UNITED STATES PATENT AND TRADEMARK OFFICE

10/589,314

Office Action Summary	Application No. 10/589,314	Applicant(s) BOURLION ET AL.	
	Examiner Fangemonique Smith	Art Unit 3736

DETAILED ACTION

**FIG. 2A**

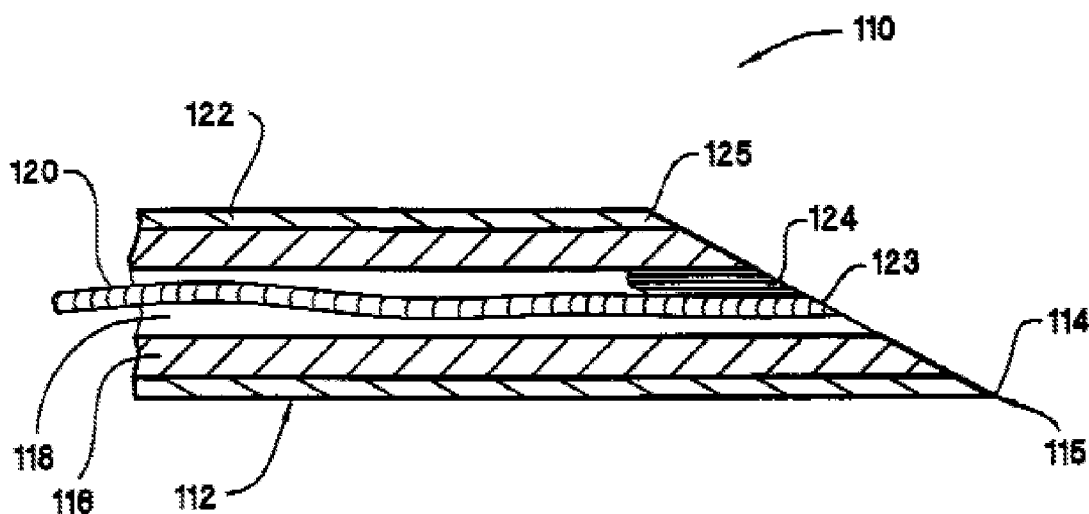
The electrodes are positioned on the penetration instrument for measuring impedance between the electrodes (col. 3, lines 11-53). The electrodes are arranged such that the first electrode has a contact surface coinciding with a distal surface of the penetration instrument and the second electrode has a contact surface coinciding with a lateral surface of the penetration instrument (Figure 2A).

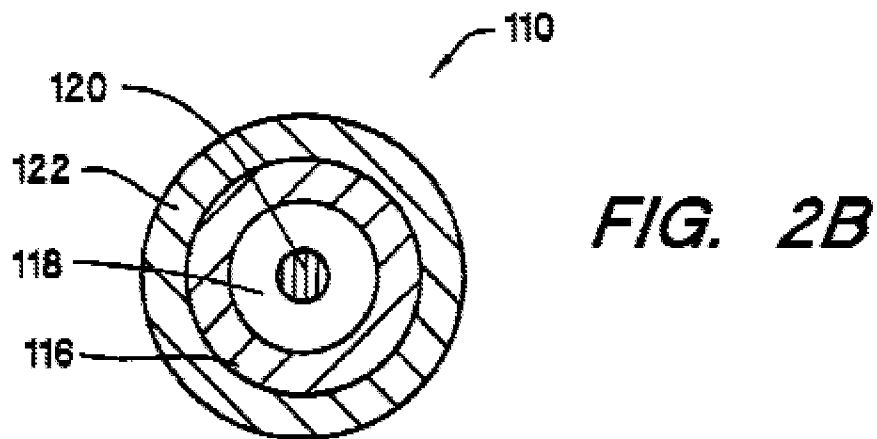
determined. Lum et al. discuss various designs for the penetration instrument including having a constant contact surface which coincides with the degree of penetration of the penetration instrument in the anatomical structure. (col. 3, lines 59-67; col. 4, lines 1- 25). Figure 2B shows the two electrodes being symmetrically and coaxially arranged. This annular arrangement has the electrodes separated from each other by insulation (Figure 2B).

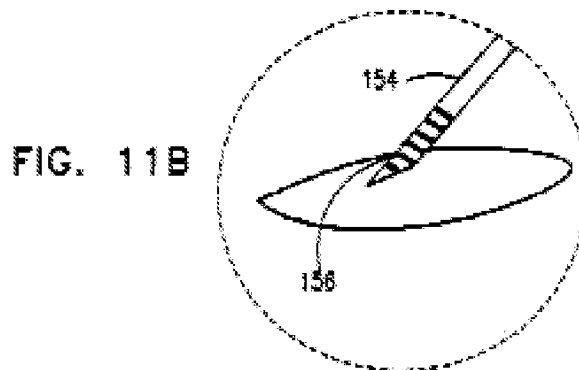
The device is designed to detect signals which are generated to measure the impedance variation and record the information during the analysis. Lum et al. disclose the device having an autonomous operating mechanism in which the device is designed to stop penetration upon reaching a predetermined depth or impedance measurement is reached. A central channel (138) is disposed within the device as described by Lum et al. This lumen is capable of being used to introduce another instrument to the target area.
